Scale: 1:50	Date: JUNE 2006
Drawn By:	Checked By:
Client: MR P. MERRINGTON & MR S. SHAW	
Project: BARN CONVERSION	
Location: LOWER DIGLEA FARM BARN BOAT LANE DIGGLE	
Local Authority: OLDHAM

Job Number:	Revision: E
-------------	-------------

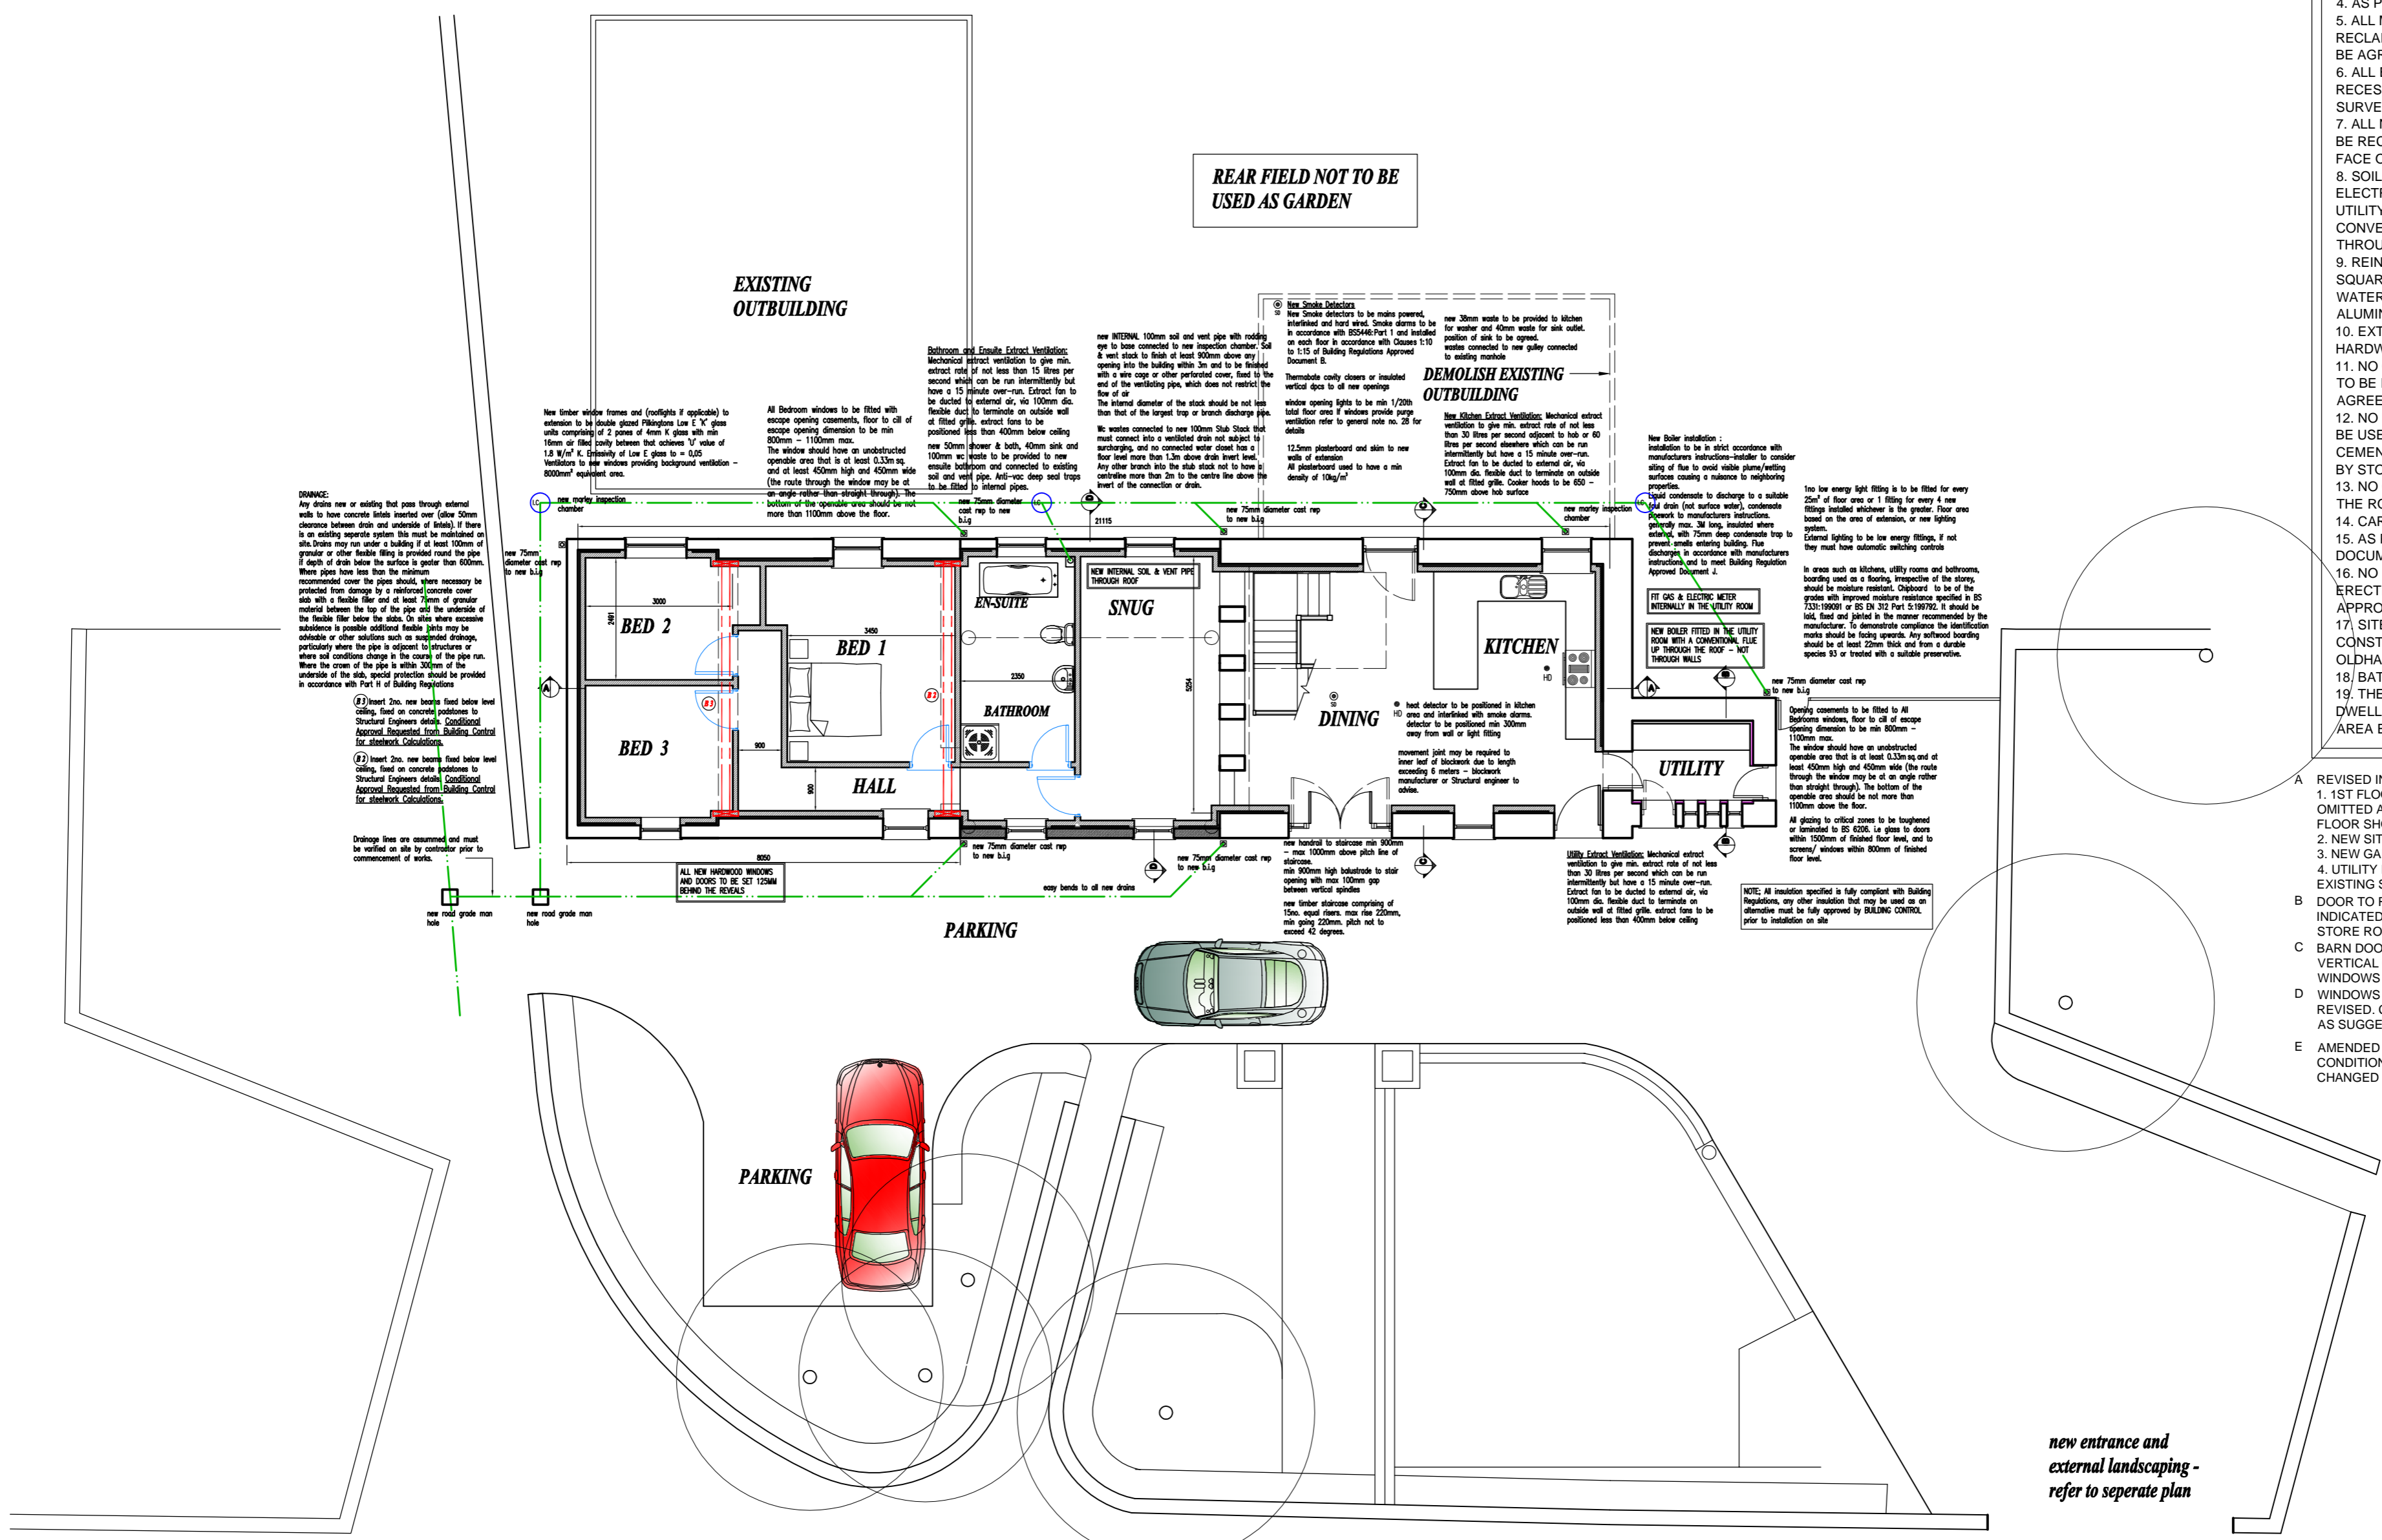
- A REVISED IN ACCORDANCE WITH PLANNERS COMMENTS
1. 1ST FLOOR EXTENSION PREVIOUSLY SHOWN OMITTED AND NEW ROOF OVER DINING AT GROUND FLOOR SHOWN.
  2. NEW SITE ENTRANCE OMITTED.
  3. NEW GARAGES OMITTED.
  4. UTILITY PREVIOUSLY SHOWN, CHANGED BACK TO EXISTING STORE.
- B DOOR TO REAR OF BUILDING REMOVED AND GARDEN INDICATED TO FRONT OF BUILDING. STORE ROOM CHANGED TO BEDROOM
- C BARN DOORS TO FRONT ELEVATION INDICATED. VERTICAL CENTRAL MULLIONS REMOVED TO ALL WINDOWS AS REQUESTED BY PLANNING OFFICER
- D WINDOWS AT 1ST FLOOR LEVEL TO FRONT ELEVATION REVISED. CONSERVATION VELUX WINDOWS INDICATED AS SUGGESTED BY PLANNING OFFICER.
- E AMENDED FOR BUILDING REGULATIONS - PLANNING CONDITIONS ADDED - INTERNAL ARRANGEMENT CHANGED - EXTERNAL DESIGN ADDED
